ADDENDUM NO.	1	DATED	8/17/2015	ADDENDUM NO.		DATED	
ADDENDUM NO		DATED		ADDENDUM NO.		DATED

Number	Description
1	Revised Table of Contents; Add NTB Nos. 5786 & 5787; SP 907-622-7, replaces SP 907-622-6; Revised BidItems; Revised or Added Plan Sht. Nos. 2, 4-11, 13-16, 22-25, 27-31, 33, 34, 38, 46-49, 85, 86, 88, 93-95, 212, 213, 220-223, 249-251, 256-259, 262, 263, 319, 320, 331-333, 2001, 2031, 6315, 6316, & 6324; Amendment EBS Download Required.

PROJECT: STP-0056-01(075) / 104101301 - Rankin

Construction necessary to Add 2 Lanes to SR 25 from SR 475 to Grants Ferry Road, known as Federal Aid Project No. STP-0056-01(075) / 104101301 in Rankin County.

DETAIL OF ALL M_L PAVEMENT TRANSITION

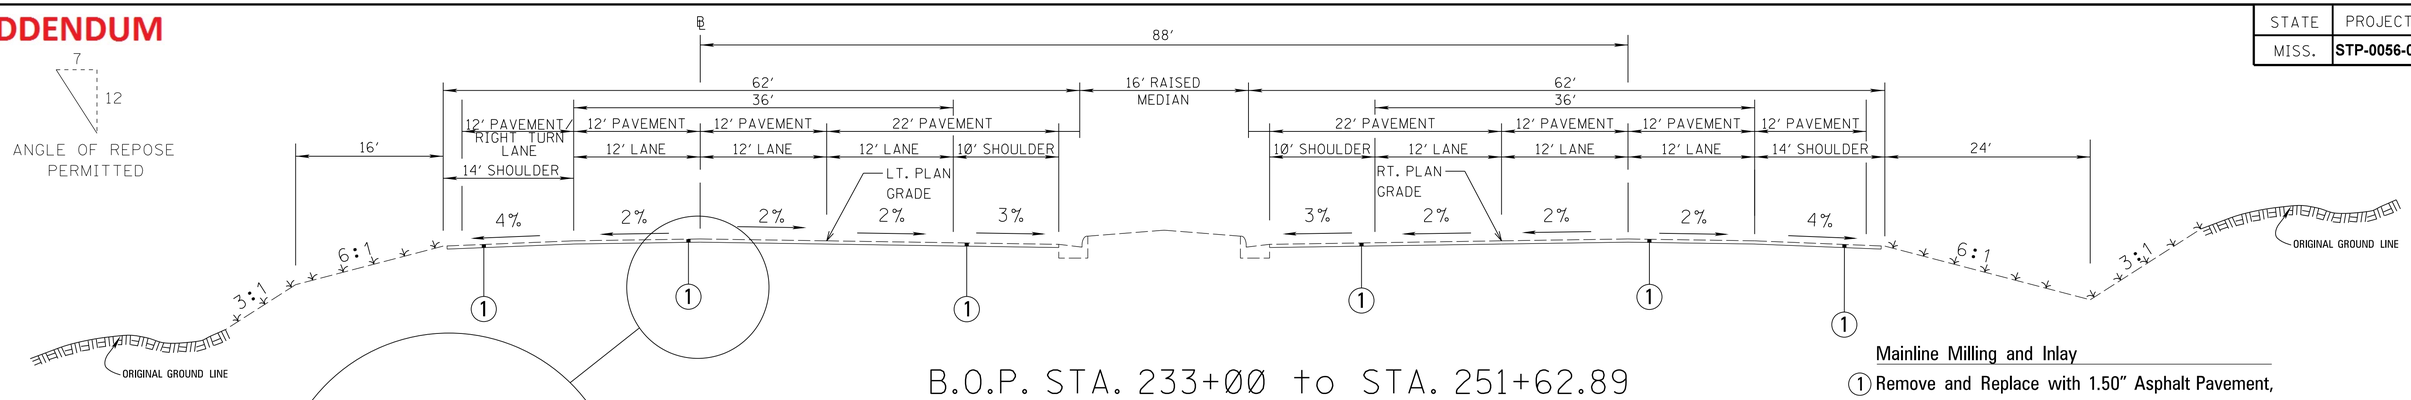
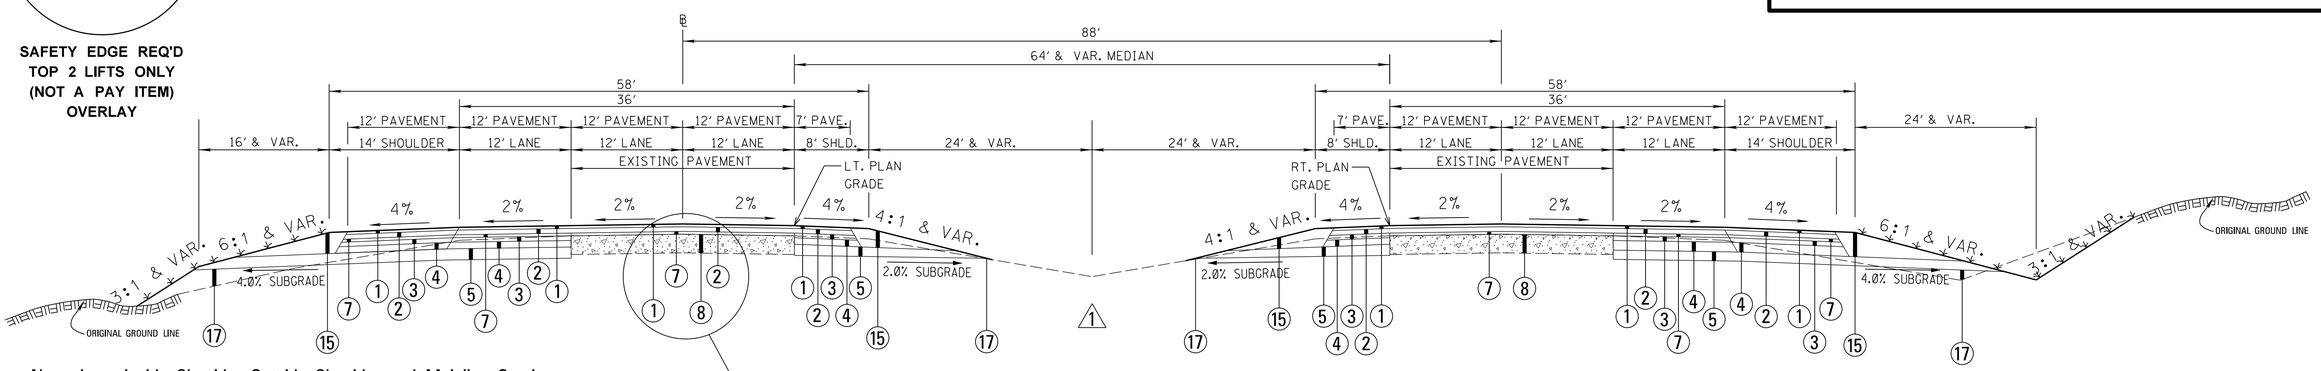
ADDENDUM

DETAIL OF MODIFIED COMBINATION CURB AND GUTTER (TYPE "3A")

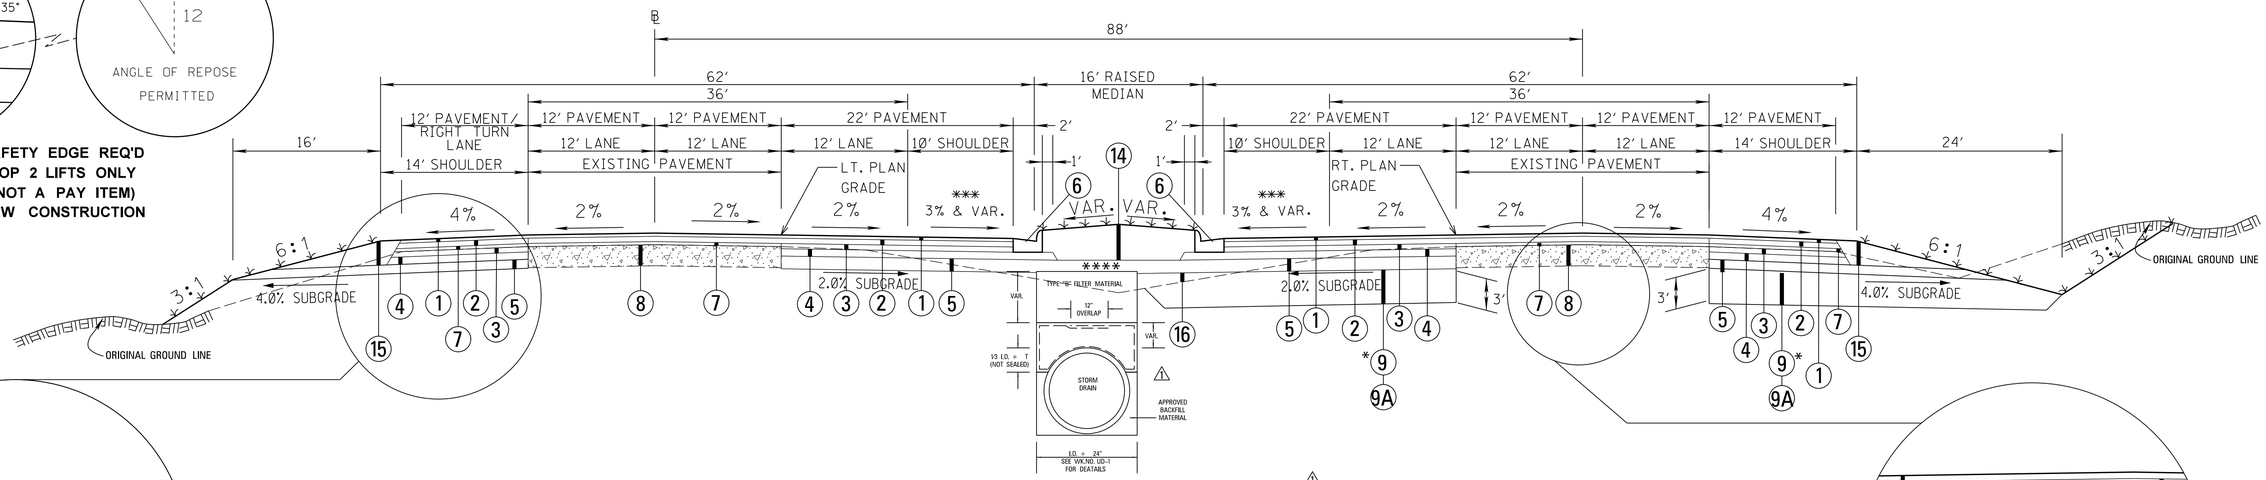
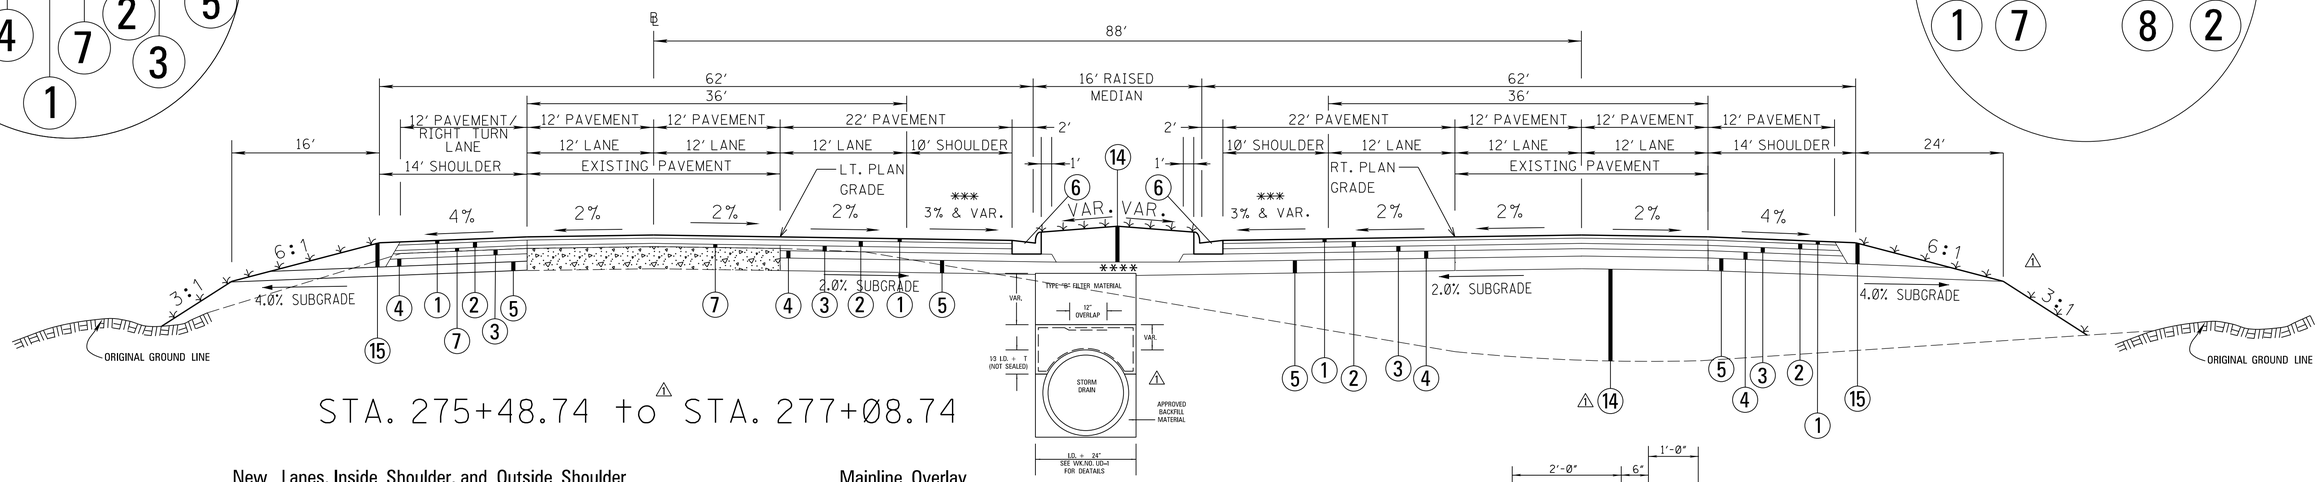
DATE	REVISION	BY
8/12/15	REVISED DETAILS, STATION LIMITS	JT

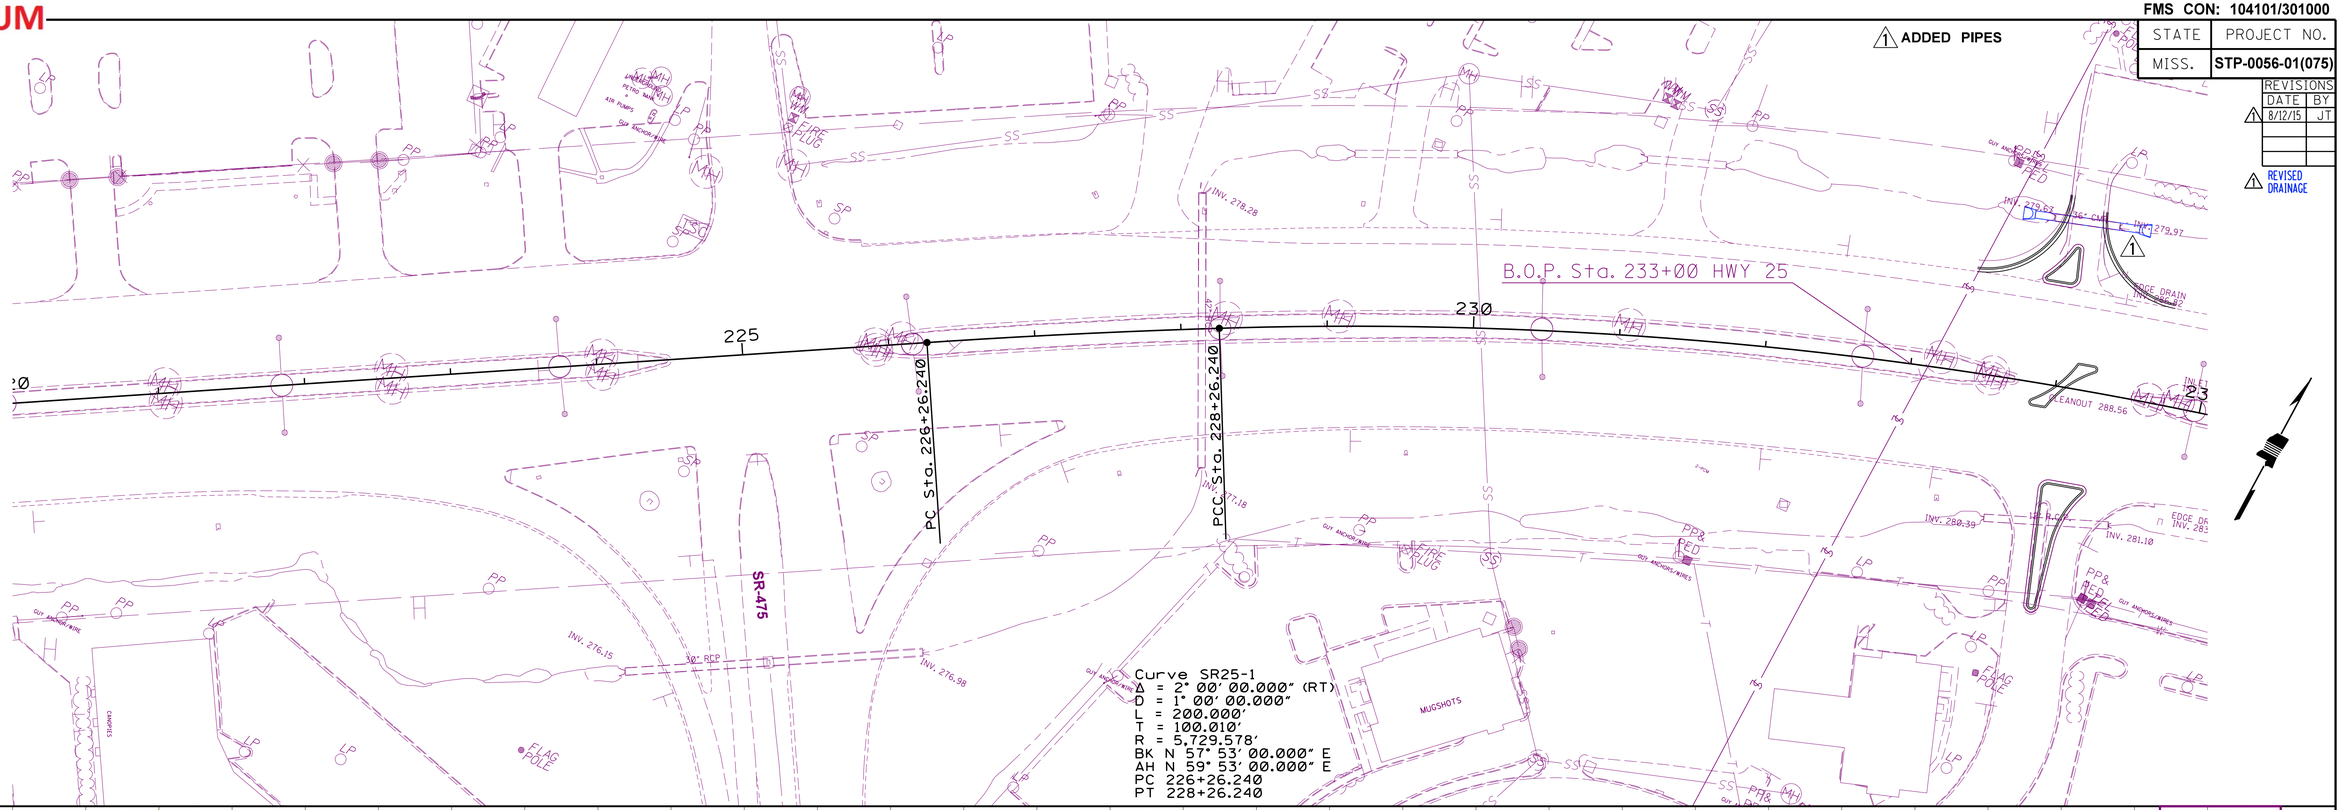
1 REVISED DRAINAGE

1 ADDED PIPES

Wk. Sh. 2LT
Sh. No. 48

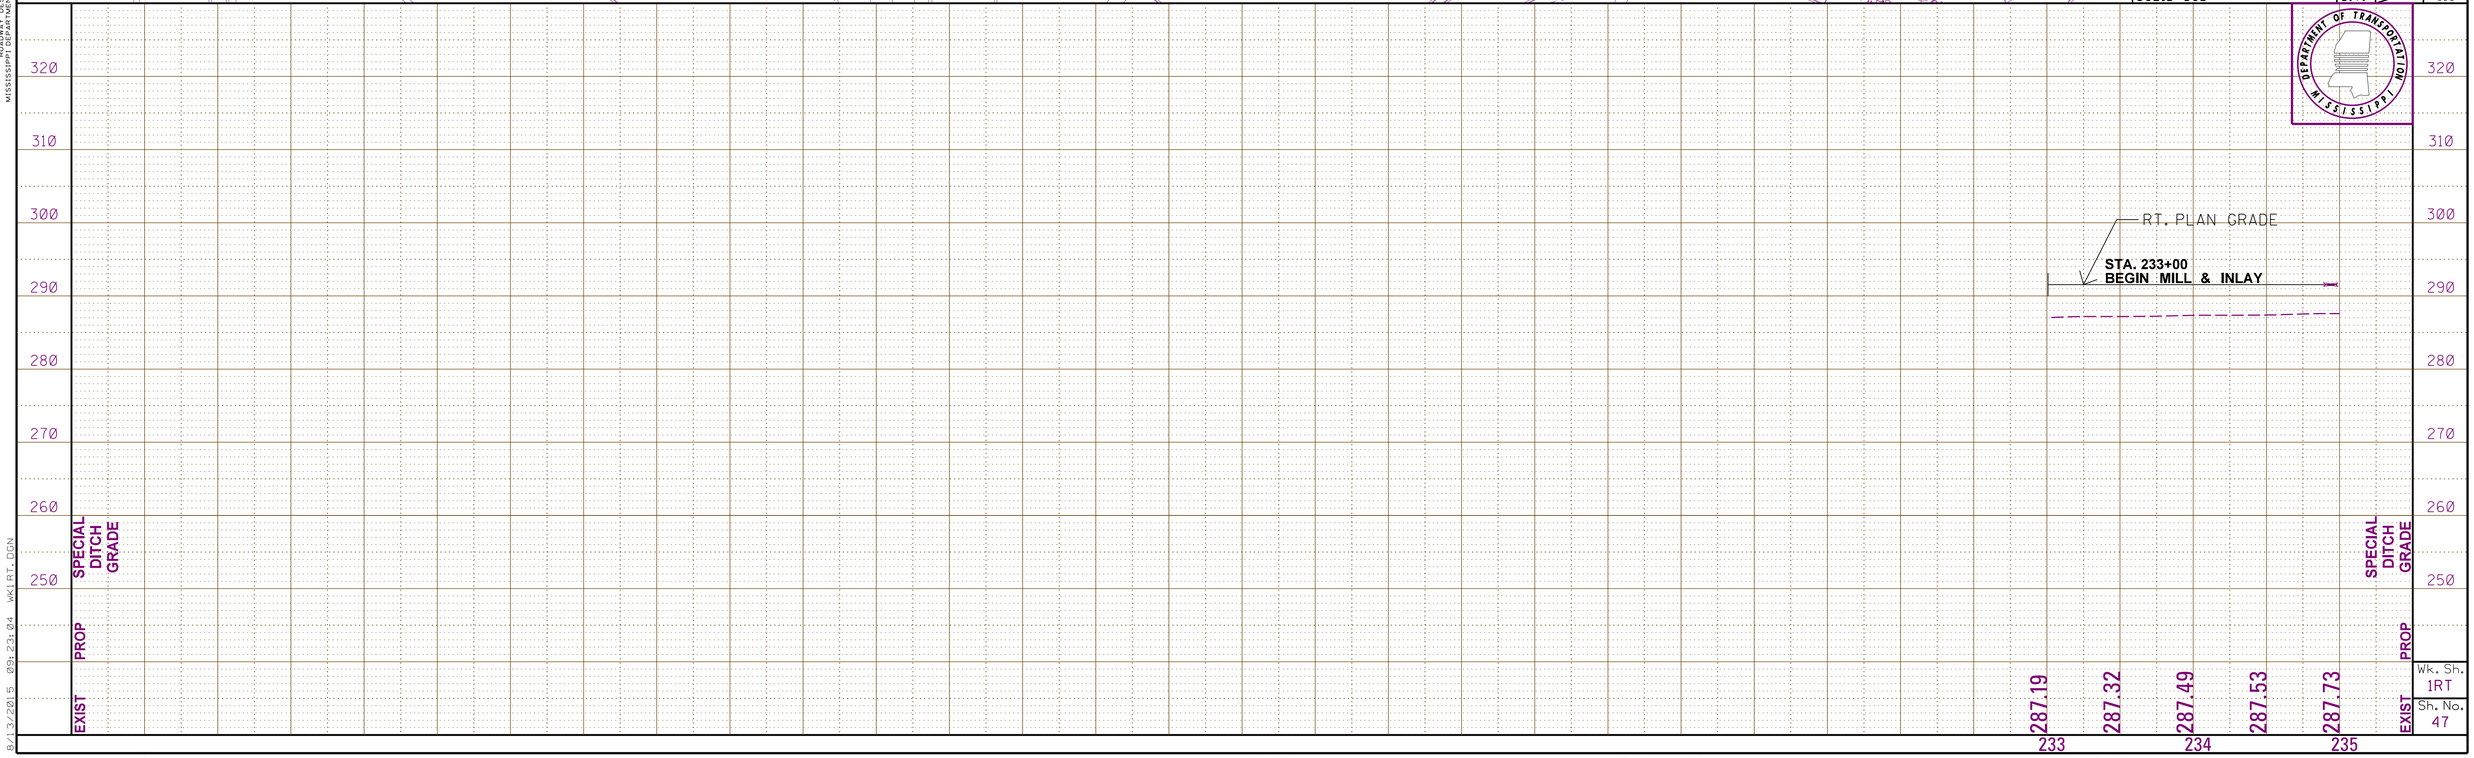
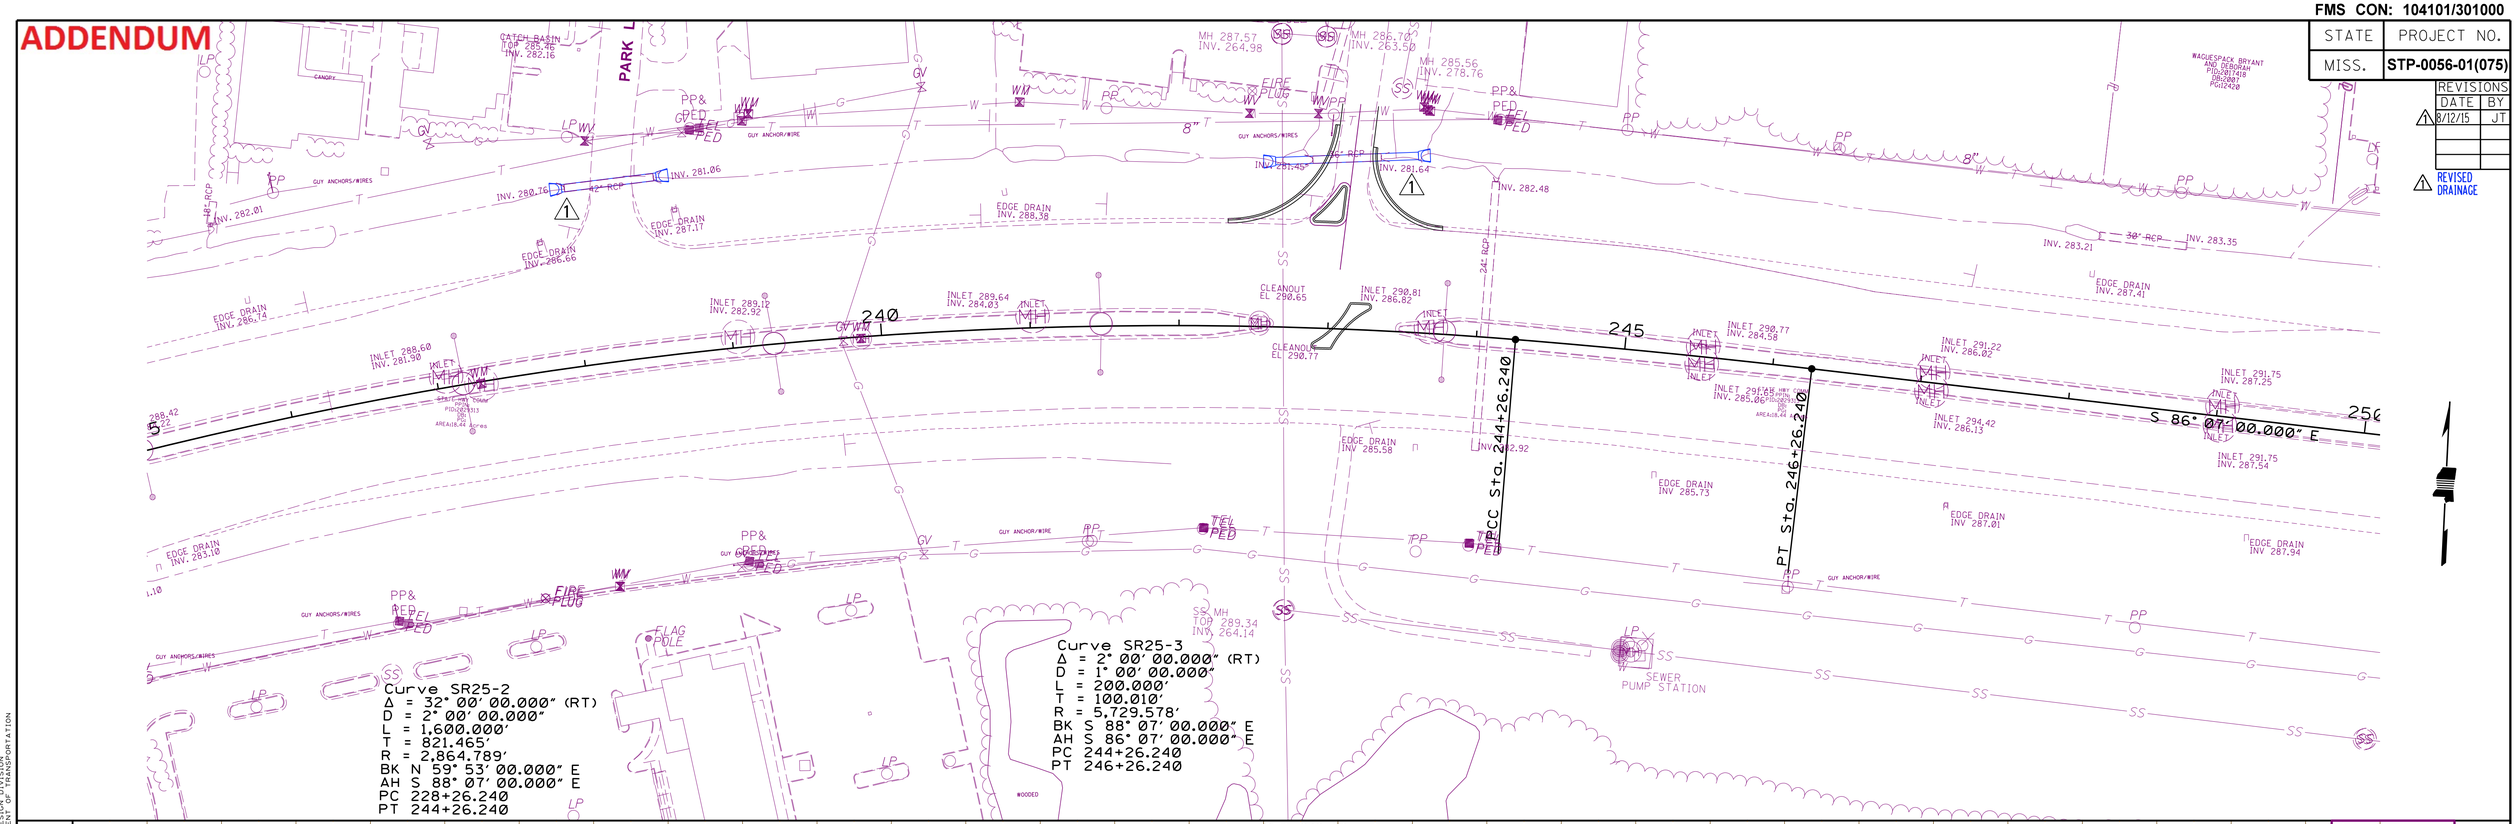
REVISIONS		
	DATE	BY
1	8/12/15	JT

1 REVISED DRAINAGE

1 STA. 243+08.35
REMOVE 46' EXISTING 36" RCP
REMOVE 36" FES LT. & RT.
96' - 48" RCP REQ'D.
2 - 48" FES REQ'D.
